Ferrari North America, Inc.

SECOND NOTICE - URGENT SAFETY RECALL

RC 60 / NHTSA 16V-341

U.S.A. RECALL CAMPAIGN NO. 60

Fig. 1

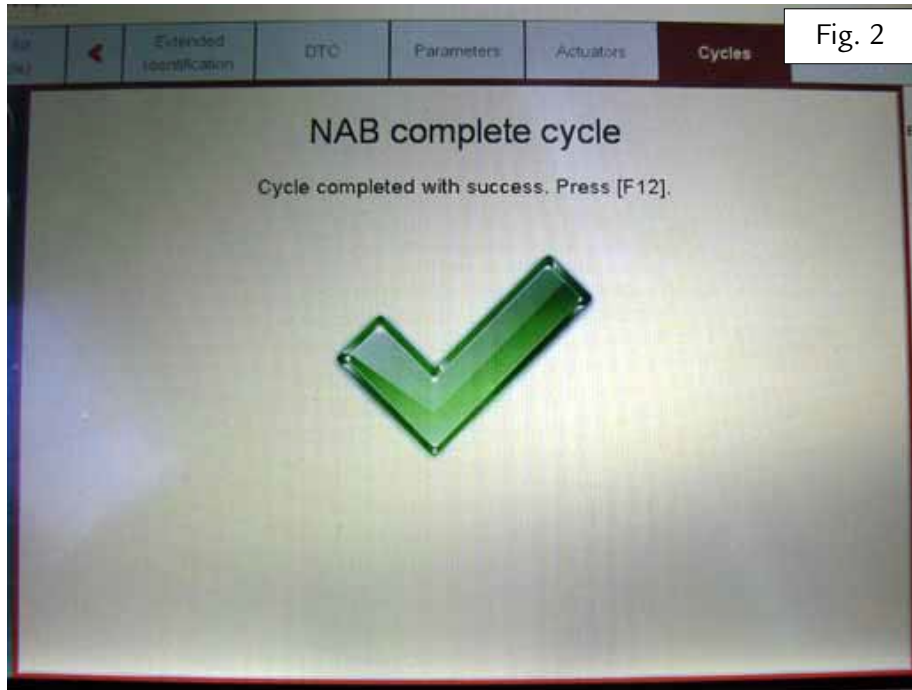
- 1.4 The installation of the new airbag module **P/N 70004993** requires the use of a special bracket to mount the airbag to the dashboard. See the Overview section of this booklet for the bracket part numbers as well as the hardware part numbers.

The new component is marked with a specific label bearing the phrase "PAB-FER-F164 SP" on the packaging, as seen in Fig. 1.

Install the NEW passenger side airbag module and bracket (as described in paragraph F4.02 step 3 of the 458 Italia Workshop Manual).
